P 30937

SEWAGE DISPOSAL SYSTEM

MARYLAND STATE DEPARTMENT OF HEALTH

SUBDIVISION Traidelphia Farms II ROAD 13255 Hunt Ridge LOT 9D
~~13340 Philadelphia Road~~

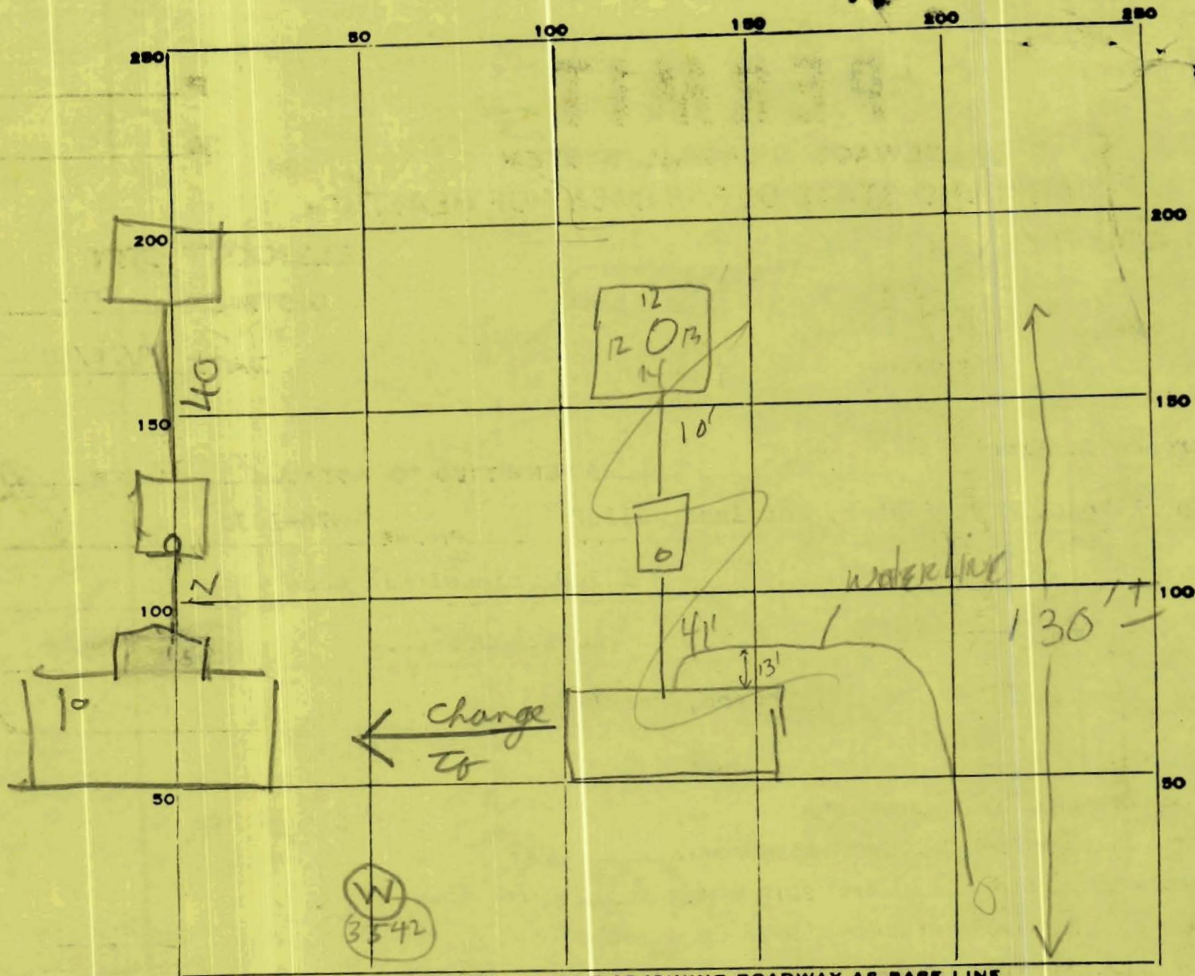
REMARKS
 9-26-80 stay work Dry well in wrong location
 above septic tank to 12' from house keep inlet to
 9' as shallow as possible (3 1/4' approx), to get to
 repair area 20 ft from house with 3 1/2 - 4"
 inlet size 9/30/80 - TANK MOVED 12 FT
 FROM HOUSE TOP OF TANK ABOUT 6" BELOW GRADE
 DATE SYSTEM APPROVED 9/30/80 INSPECTOR Raymond Hodges
